Report to: Development Services Committee

SUBJECT: RECOMMENDATION REPORT
Site plan application submitted by the Catholic Cemeteries Catholic and Funeral Services - Archdiocese of Toronto (CCFS), to permit a mausoleum at the Holy Cross Cemetery at 211 Langstaff Road

FILE NO: SC 15 243928

Figure 6

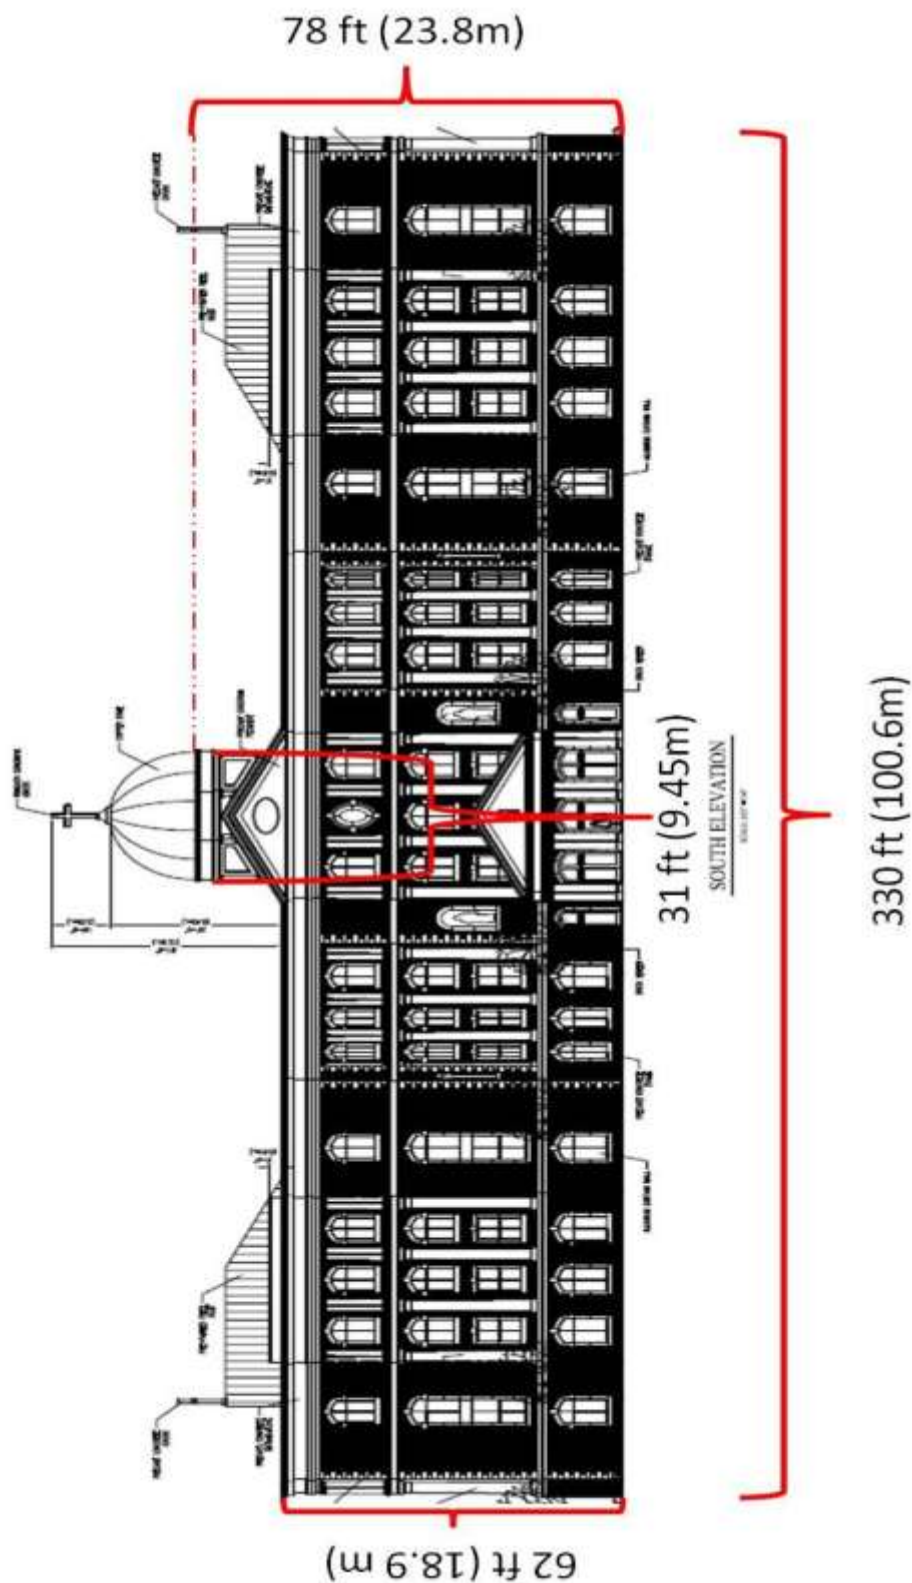
- 3) The proposed building height. (The height to the top of the cross is approximately 31.6m (103'8") high. The dome and cross are not included in the height as defined in the zoning by-law);

The wall of the mausoleum that is facing the residential lands is approximately 100.6m (330ft) long. Ninety percent (90%) of this length is 18.9m (62ft) high which is 1.5m (5ft) taller than the existing mausoleum to the east. The structural base around the dome has a height from average grade of 23.8m (78ft). It is approximately 9.45m (31ft) or 10% of the length of the entire building (Figure 6). The dome itself and cross are architectural features and are not included in the calculation of building height under the by-law.

- 6) The applicant was asked if a compromise could be made with respect to the building height;

CCFS has advised that due to the floor to ceiling heights needed to accommodate the four storey building, the height requested was necessary.
